# PIPE LINE NEWS

## Model OP10 Valve

Change to internal design

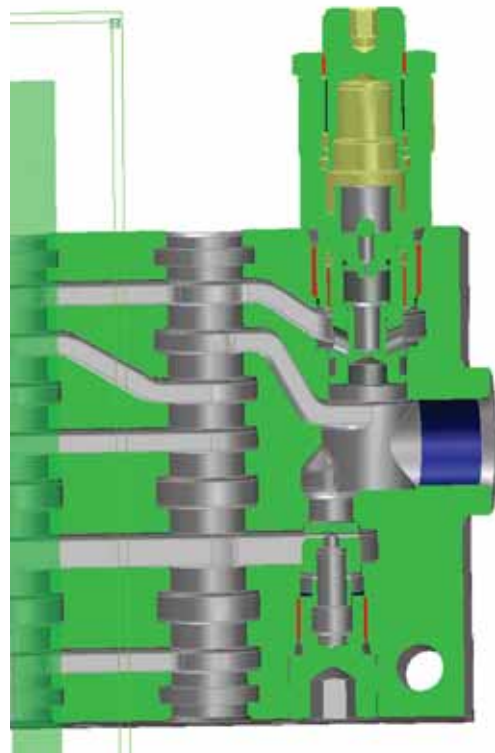
The OP10 valve is undergoing an upgrade which will commence in August 2005 with the single spool valve being the first model to receive the changes. The check valve will be repositioned into its own cavity placed at the rear of the valve. The inlet port will be reduced in its length of protrusion from the valve body. The relief will be changed to a new design which is pilot operated and has a new cavity.
